## DOORS

June 16, 2023

### **Product Change Notice - Three Seasons Door fasteners**

**Current bracket and handle with screws**

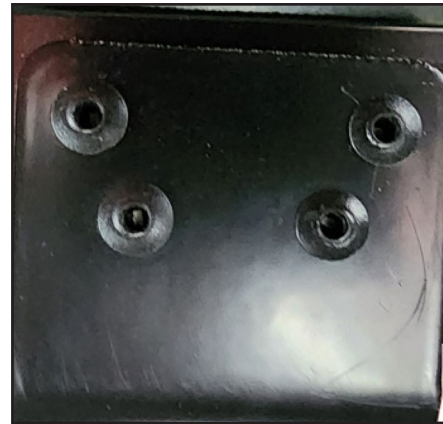
To improve product performance, Lippert intends to change the fasteners on Three Seasons Door handles and brackets from screws to rivets.

The rivets create a more secure assembly than screws, which have the potential to be cross threaded on installation at the plant.

There is no change for the customer in installation or operation. There is no part number change for the doors and no price change. The change is expected to begin on a running basis in about a week.
